SIB 52 07 25

M5 HEAD RESTRAINT GROANING NOISE

2026-01-28

This Service Information Bulletin (Revision 2) replaces SI B52 07 25 **dated October 2025**.

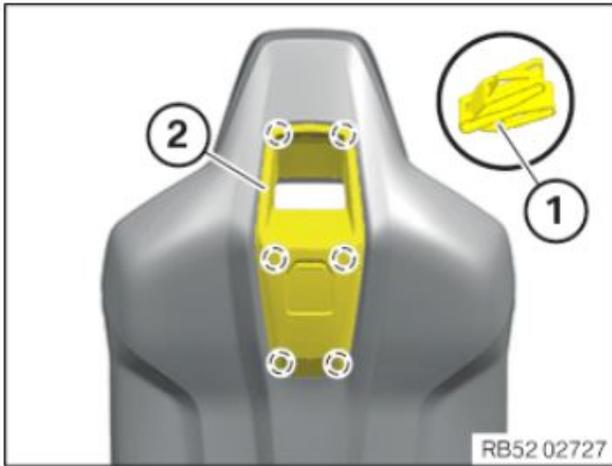
The edge of the aperture trim rubs against the seat leather upholstery at the point of contact.

Replace the aperture trim on both seats in case of a noise concern with revised part number 52 10 7885235.

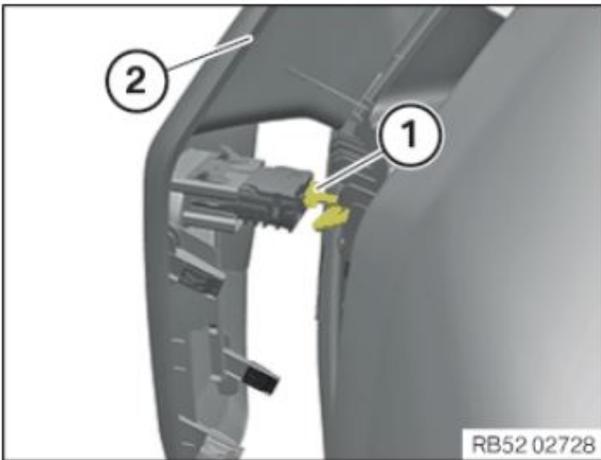
If the decorative trim causes groaning noises, **replace the decorative seat aperture trim (1) with an improved part.**

To remove the front decorative seat aperture trim, you must first remove the trim (2) from the rear of the seat. There are 6 retainer clips (1).

The revised front aperture trim can be identified by a green dot sticker.

The improved part with the green dot sticker has strips of felt attached. **Do not install the part if the felt is missing.**
